Instruction Sheet for BrewZilla Gen 3.1.1 Board (Upgrade Mod)

How to tell if you have a BrewZilla 3.1 or BrewZilla 3.1.1

Gen 3.0 (Old Main PCB)   Gen 3.1 and Gen 3.1.1 (New Main PCB)

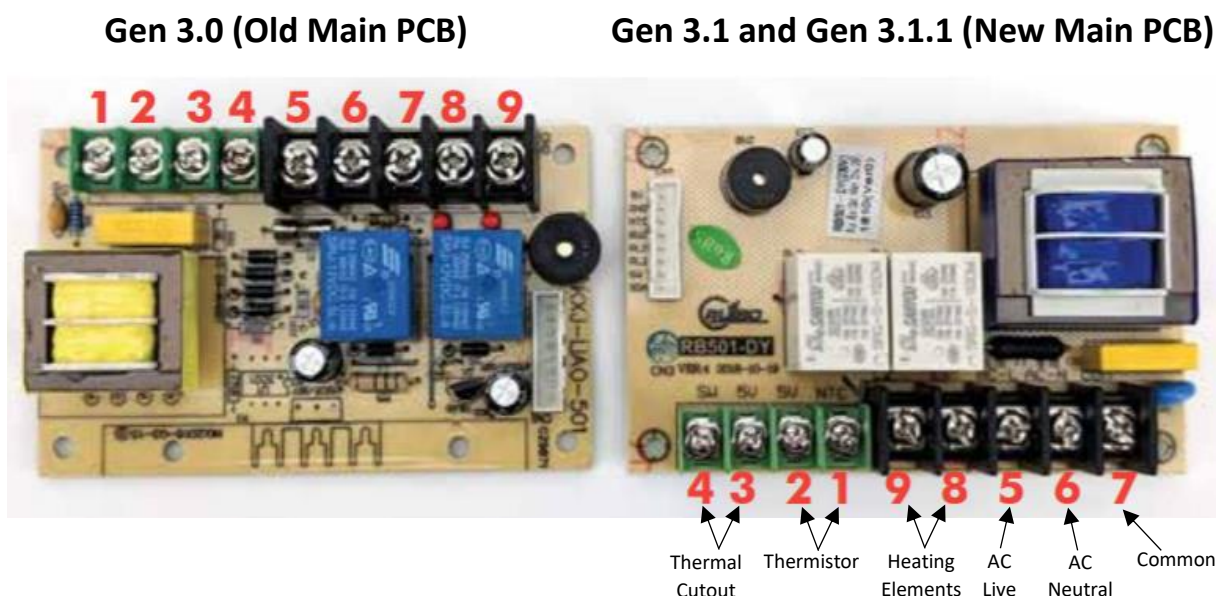
Disconnect the wires using a phillips head screw driver one at a time and taking note of the new wiring position on the new board replace the wires one at a time. Refer to the image below to determine where each of the wires need to be placed.
